Re: **Second Submission Review** – Murphy Creek East/Harvest Ridge Master Plan Amendment

Application Number: **DA-1250-46**
Case Number(s): **2007-7003-03**

MAINTENANCE ELIGIBILITY PROGRAM (MEP) MEP Referral Review Comments

Project Name:	Murphy Creek East/ Harvest Ridge Master Plan
Drainageway:	Murphy Creek and Murphy Creek East
MEP Phase:	Referral
MEP ID:	106733
RSN:	1408408

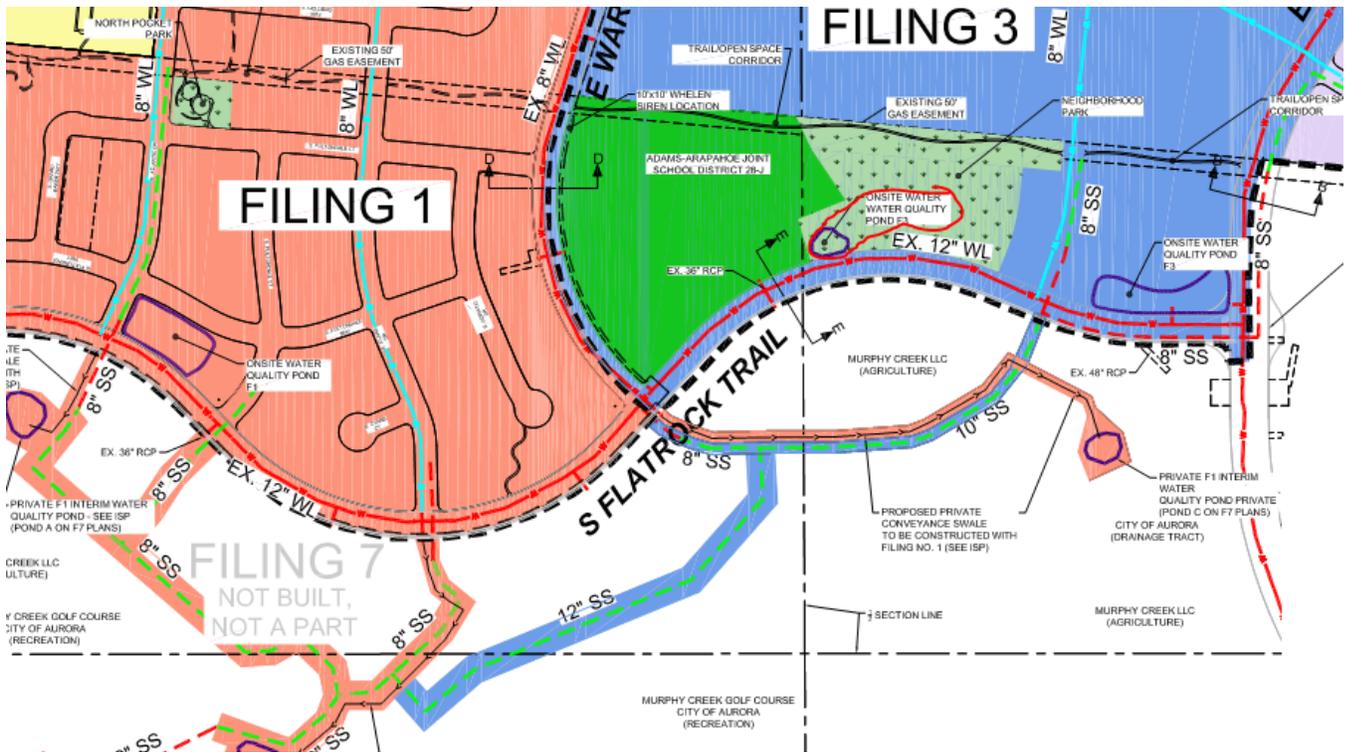
4. Culvert A should be designed to convey the flow that was documented in the OSP (2008) at South Harvest Road. Private detention ponds that may be constructed upstream of this location cannot should not be considered when designing 100-year conveyance infrastructure.

RESPONSE: *Upstream ponds are currently being designed for Full-Spectrum detention to release at 100-yr Historic per previously approved reports.*
